PROPOSED JULIET WINDOW AMENDMENTS

Owner-prepared planning drawing pack | Revision P03 | 28 July 2026

Property	35 Brooksby Road, Tilehurst, Reading, RG31 6LZ
Applicant	Mrs Sylwia Ochnicka-Bento
RBC reference	210278 / PL/21/0278
Existing consent	Certificate of Lawfulness for proposed loft conversion, decision 9 April 2021
Certified drawing	P1189A-03 Revision A, dated 7 April 2021
Approved dormer	Rear dormer, 4,820 mm overall width

B. PROPOSED REAR ELEVATION - JULIET OPENINGS

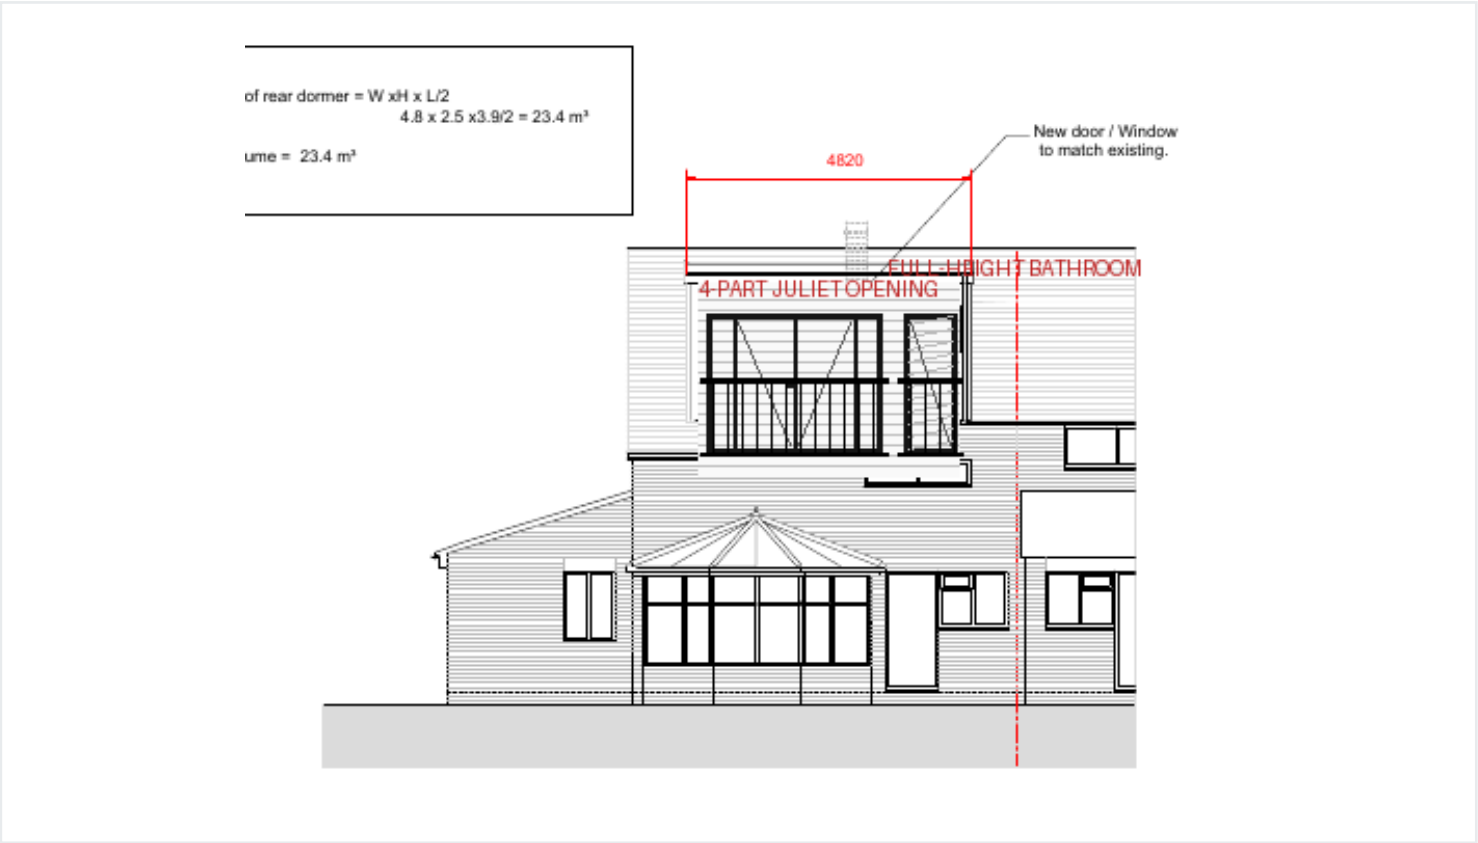
Dormer envelope unchanged. Window/door configuration revised only.

1. Bedroom: 2,200 mm wide x 2,100 mm high preliminary structural opening; verify on site.
2. Bedroom composition: 350 fixed + 750 inward-opening + 750 inward-opening + 350 fixed.
3. Bathroom: 700 mm wide x 2,100 mm high preliminary full-height tilt-and-turn unit; obscure safety glazing.
4. Black metal vertical-bar Juliet guards, 1,100 mm minimum guarding height; no platform.
5. Frame colour: anthracite grey / black to match the selected external palette.
6. Juliet thresholds remain at loft finished-floor level; openings are wholly contained within the dormer face above the first-floor floor/roof zone.
7. First-floor bathroom and relocated bedroom windows remain physically separate below and must be shown/checked on their own first-floor elevation detail.

PROPOSED LOFT PLAN - WINDOW AMENDMENT LOCATIONS

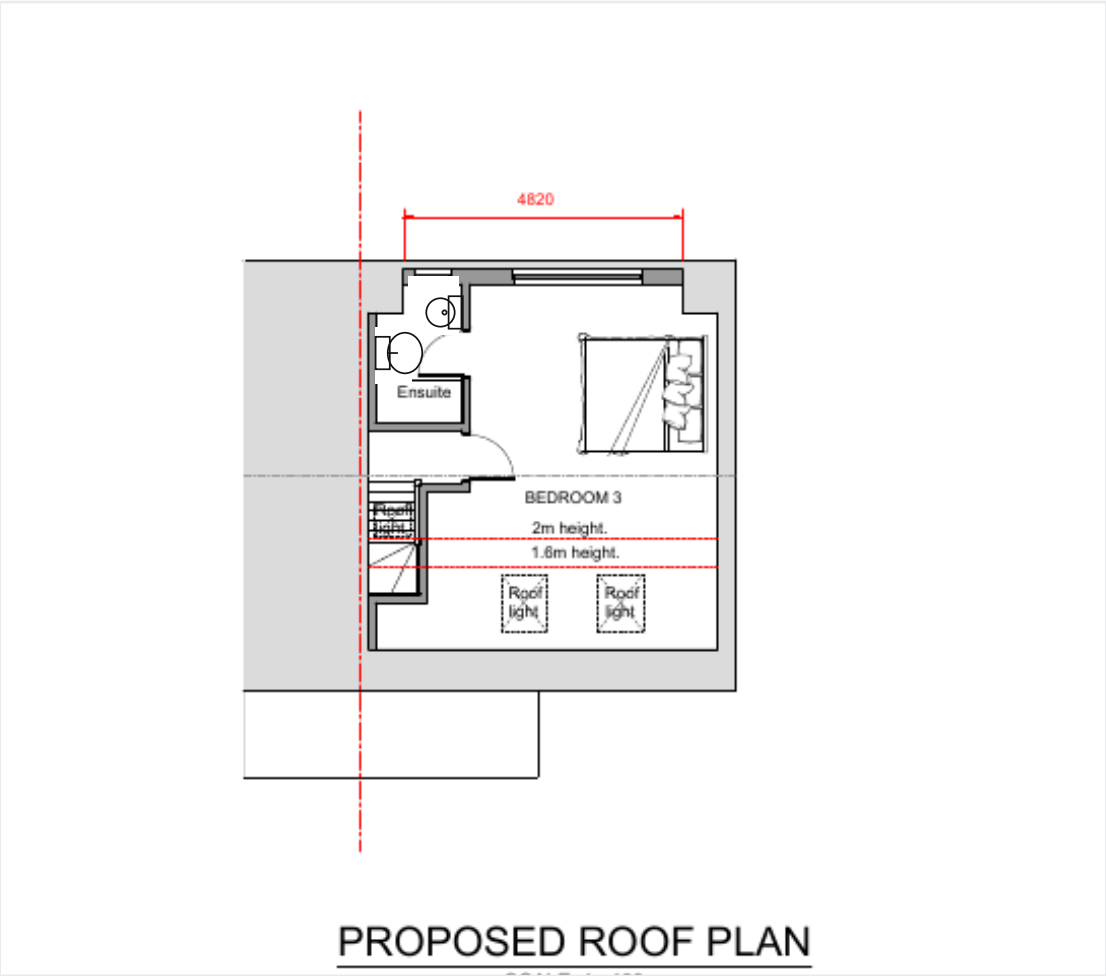
- JW-01 and JW-02 are centred within their respective rooms as closely as structure and internal finishes permit.
- Maintain adequate solid dormer cheek and separating stud widths as confirmed by the structural engineer.
- No change to the certified 4,820 mm dormer width, footprint, height or roof volume.
- Final clear opening and ventilation performance to satisfy Building Regulations and supplier requirements.
- Bathroom mechanical extract ventilation remains required irrespective of the openable window.
- Ensuite WC and basin positions swapped; both fittings remain clear of full-height opening JW-02.

JW-01 - BEDROOM

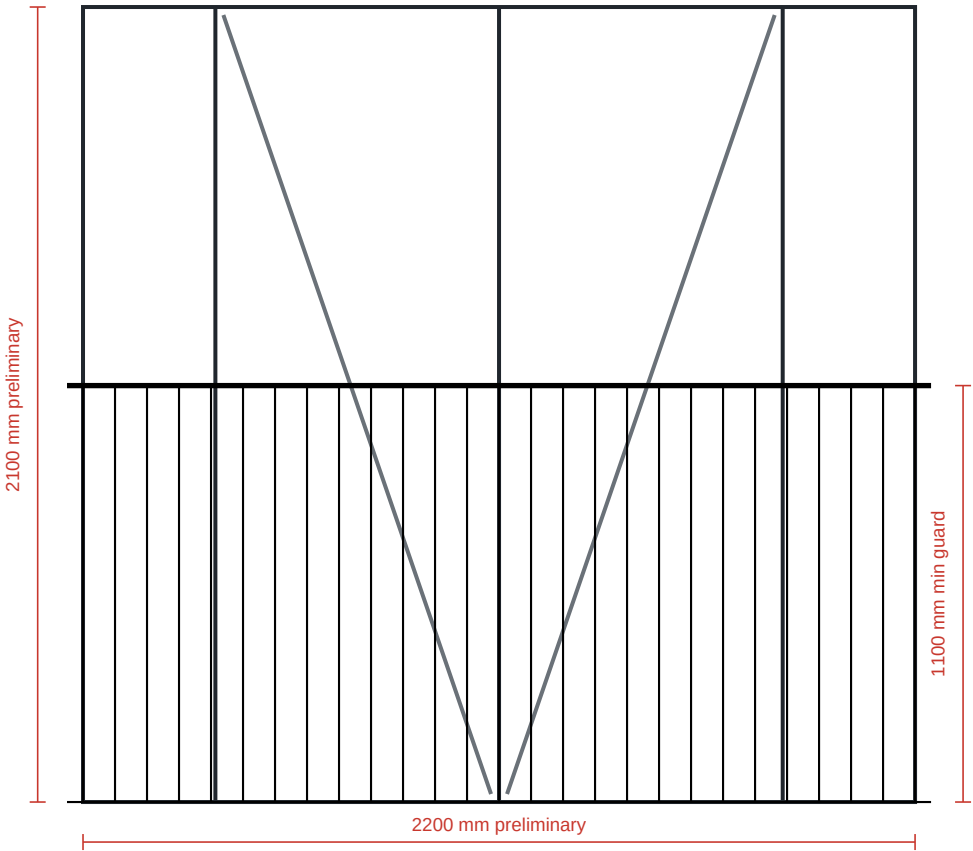
Two inward-opening central doors with fixed full-height sidelights

JW-02 - BATHROOM

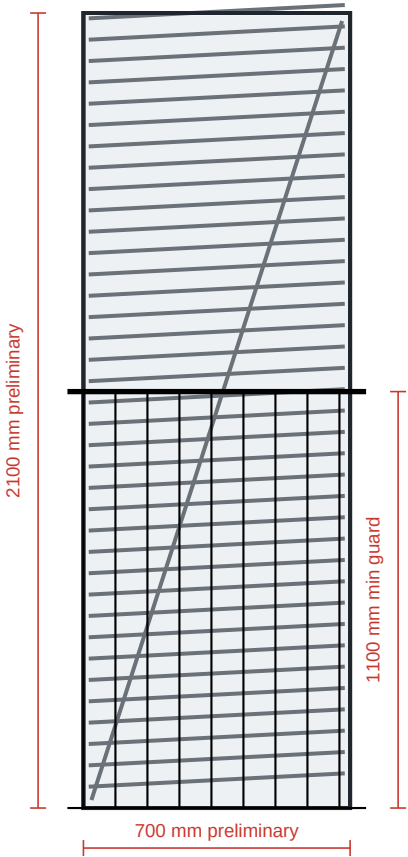
One full-height inward-opening tilt-and-turn unit; obscure safety glazing
